ADDENDUM NO. 1

DATE: AUGUST 5, 2025

DATE: 24 JUNE 2025

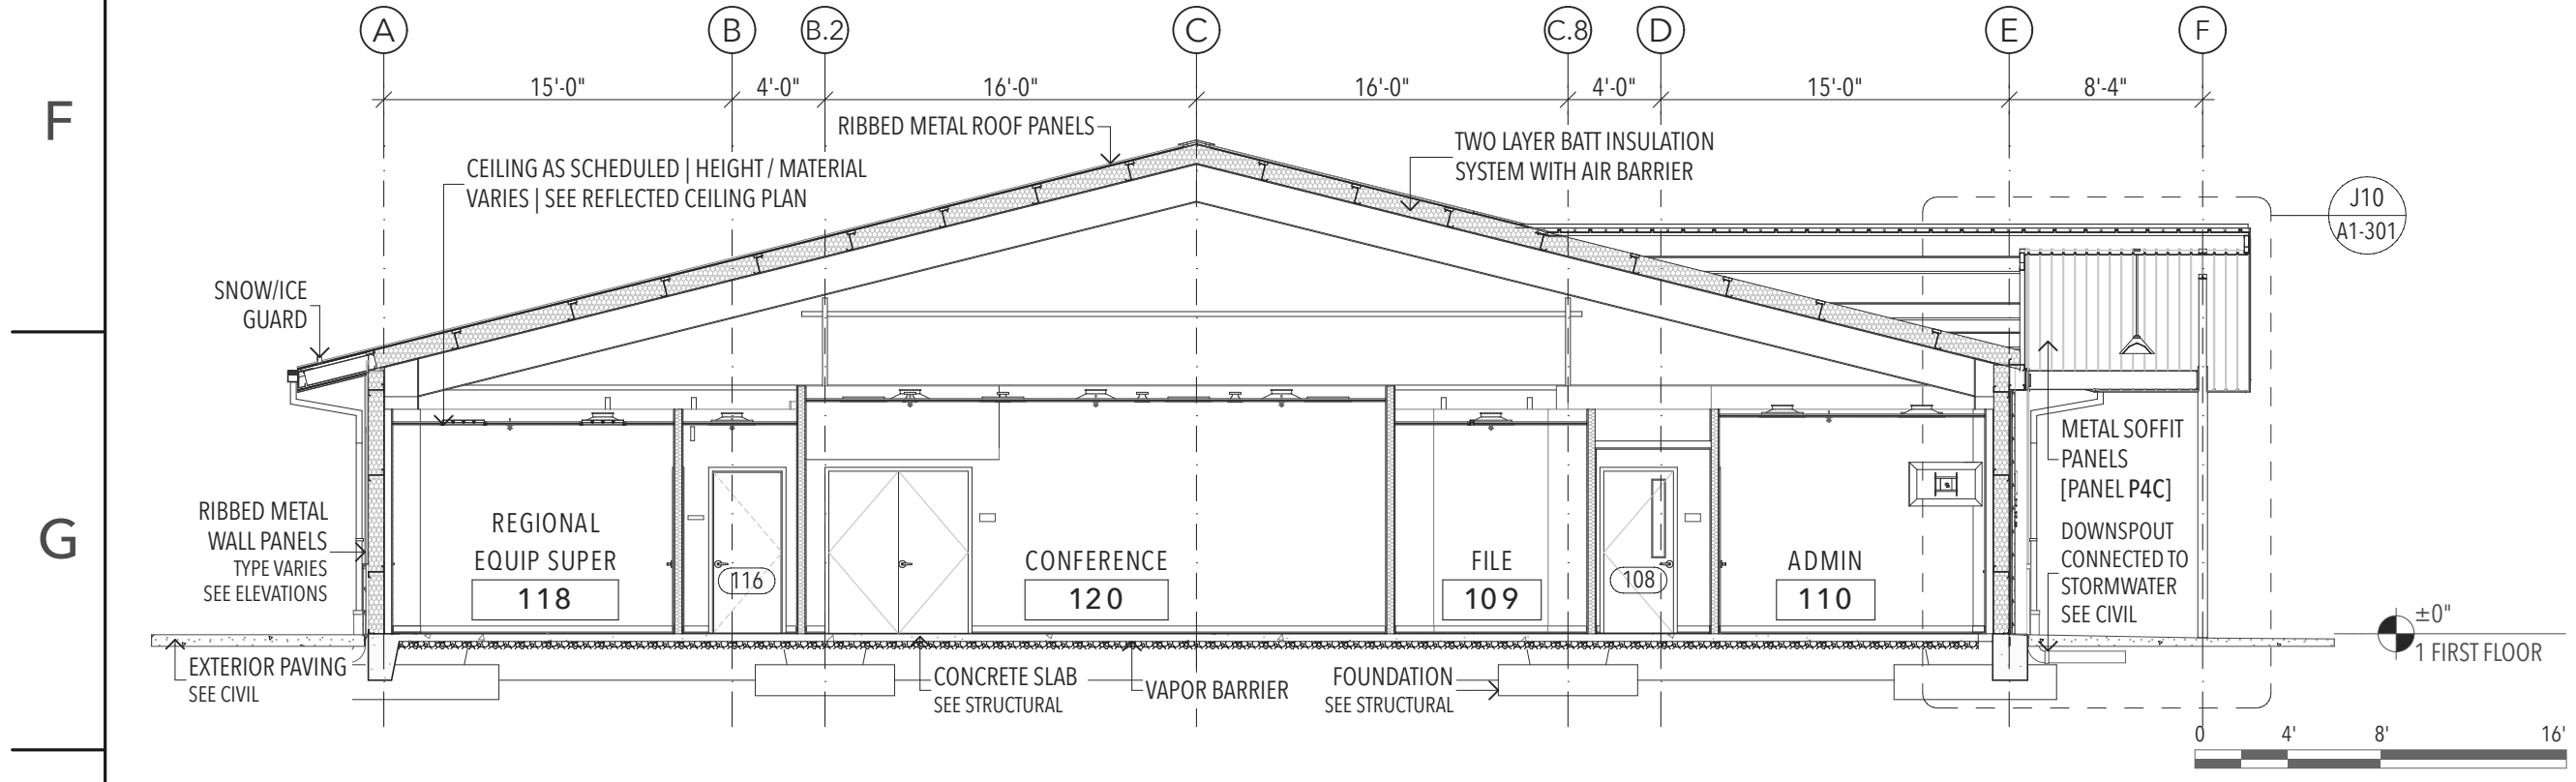
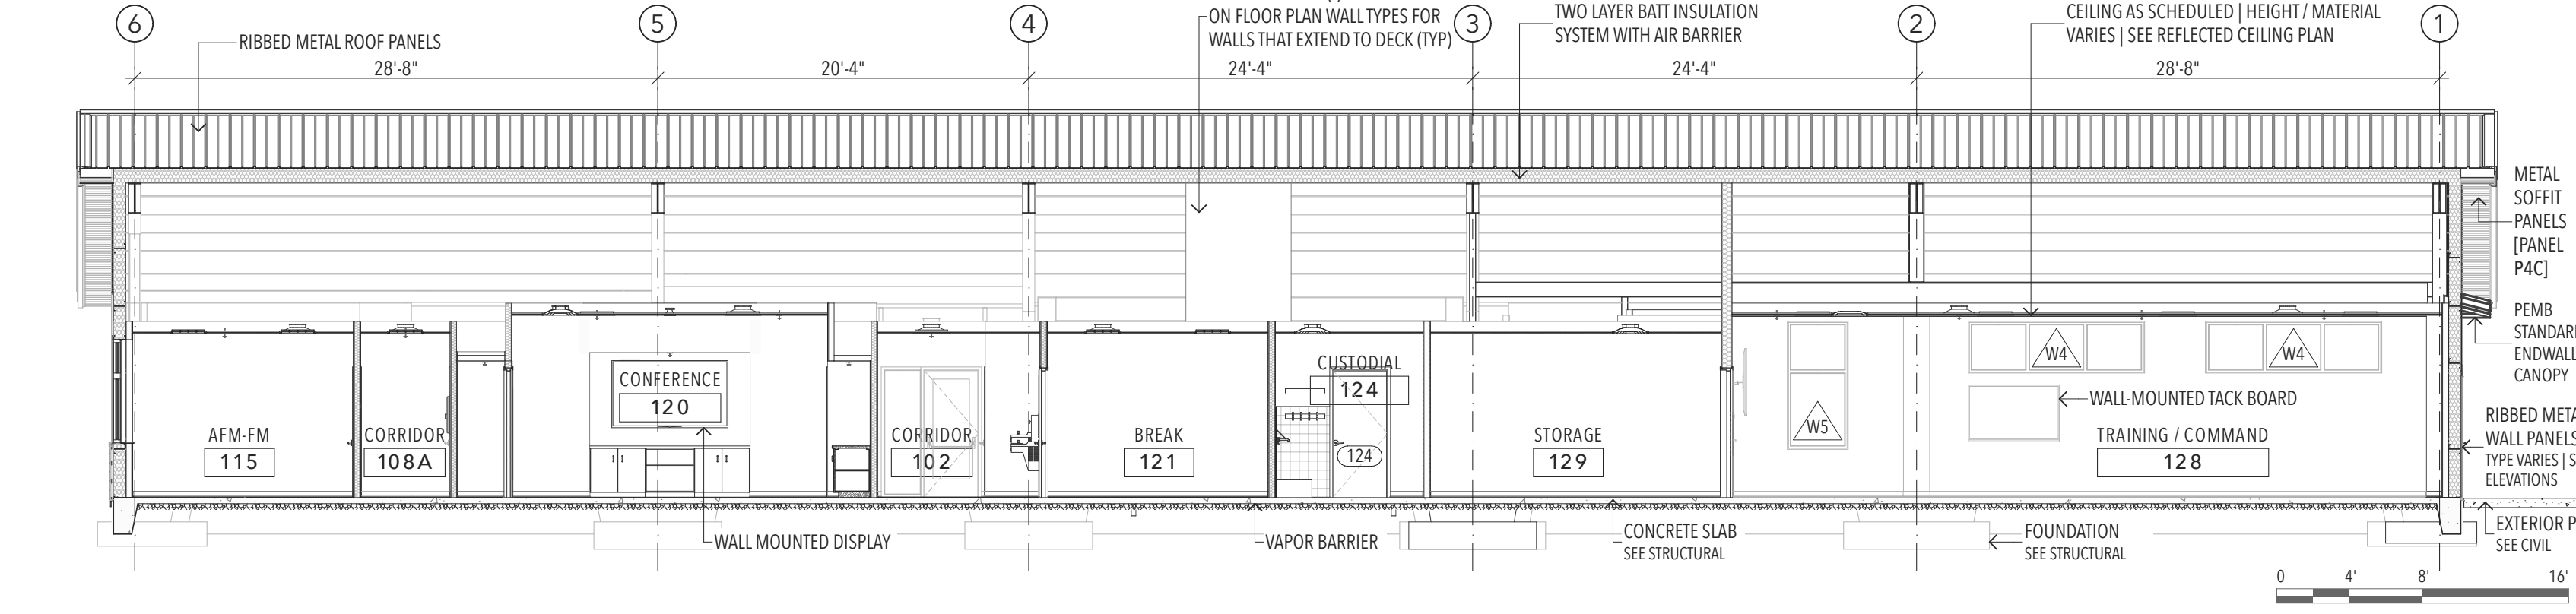
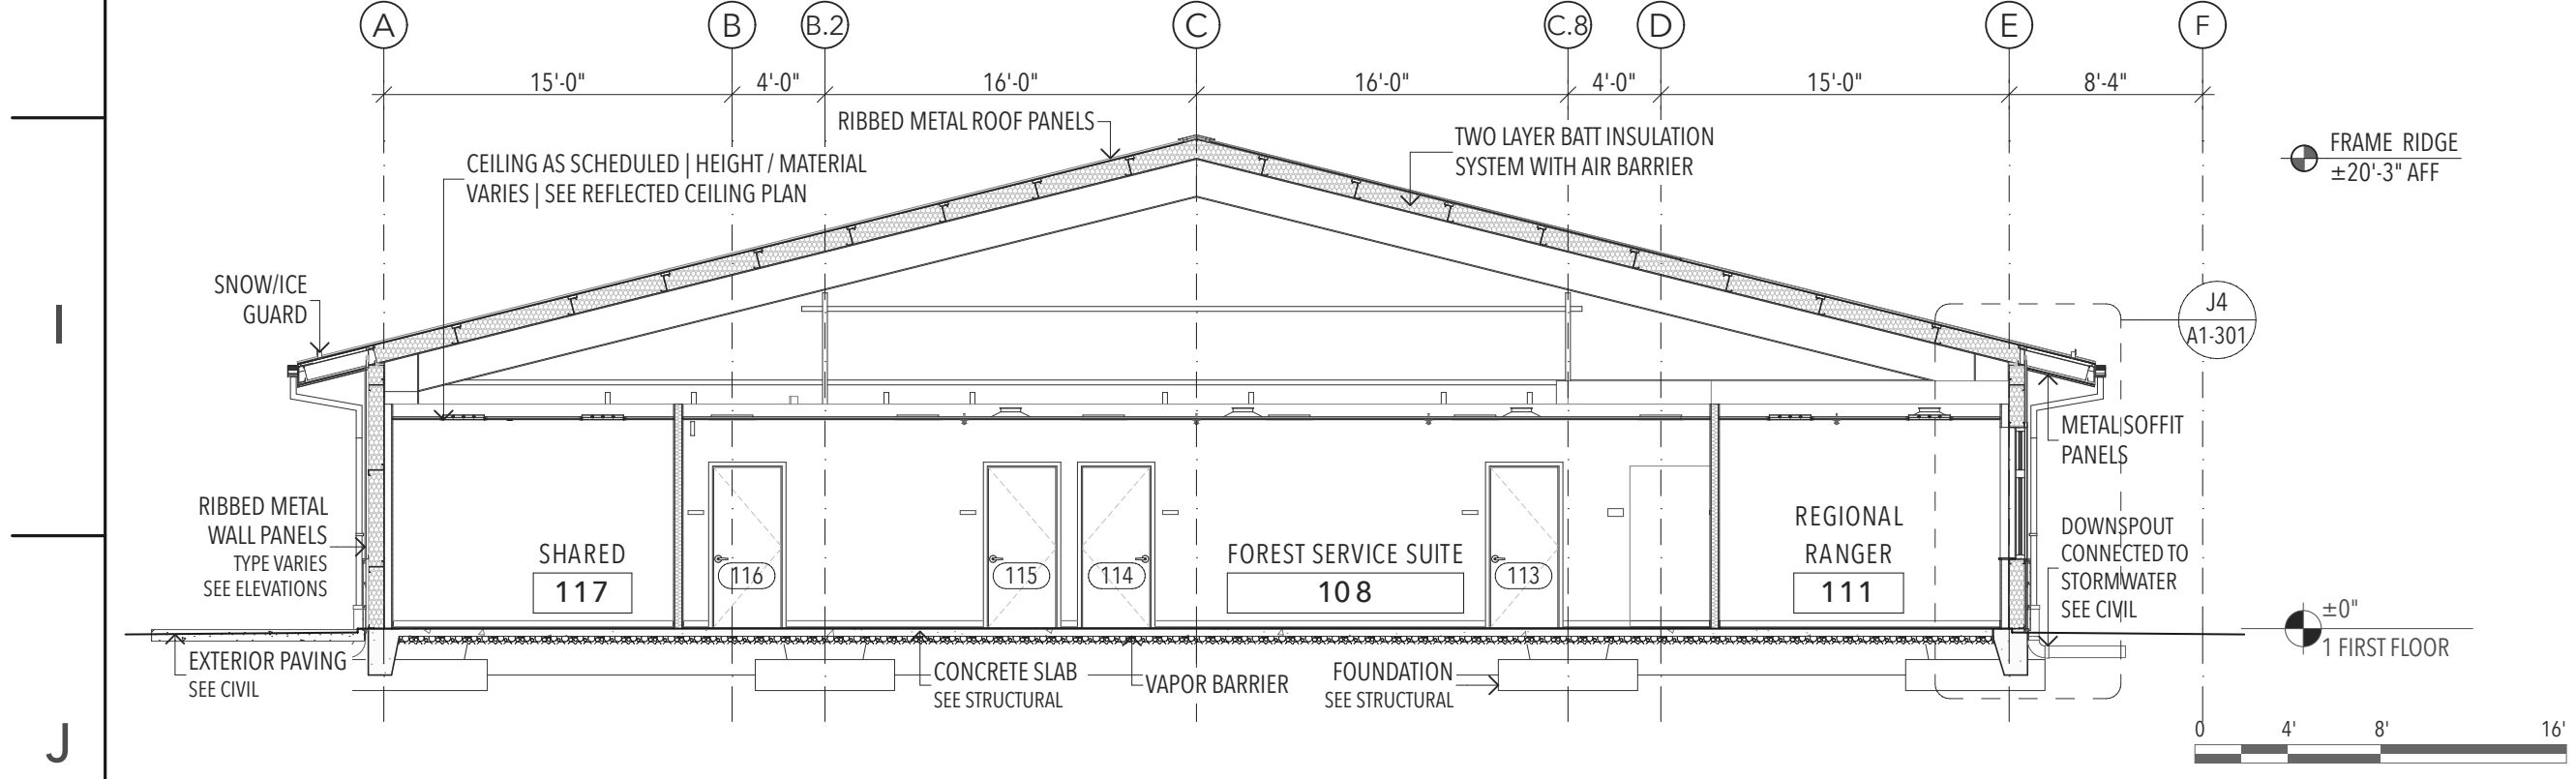
1. **REPLACE** Sheet A1-201 – Administration | Building Elevations with the attached, **UPDATED** Sheet A1-201 – Administration | Building Elevations (Revision 1, Dated 08/04/25). Drawing updated to address a graphic issue with how the south elevation covered entry is represented on the D1/A1-201 West Building Elevation and D8/A1-201 East Building Elevation.
2. **CLARIFICATION:** The P3C metal panels shown on Building 02-Maintenance Building above the Bay 201A, 201B, 201C, and 201D coiling doors are to have the same finish / match the wood grain finish of the P3C and P4C metal panels on the Building 01-Administration Building. Panels P3C and P4C are also used at the southeast corner of Building 02-Maintenance Building. The P3C and P4C metal panels are included in Specification Section 074213- Formed Metal Wall Panels.
